### 2 Type of change

Change of rating marks on the product.

Product Change Notification					DD21 Power entry modules		
owner	creation date	release date	released by	change order no	rev	page	D10-032-534
sariogar	04.12.2018	06.12.2018	limachcl	2016784	A	1 of 2

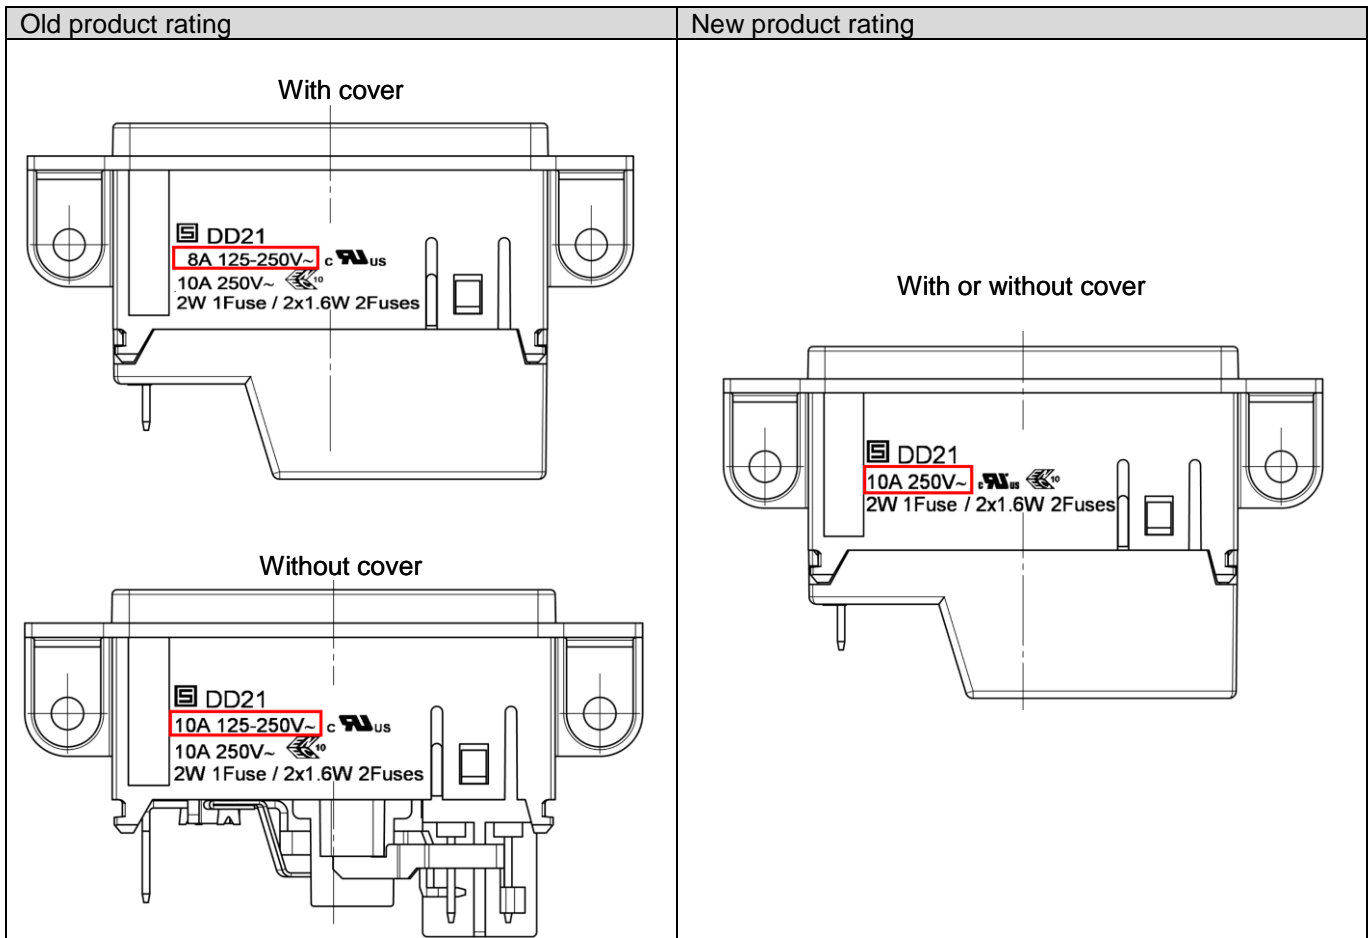
Standards update according to the new UL/CSA 60320-1.
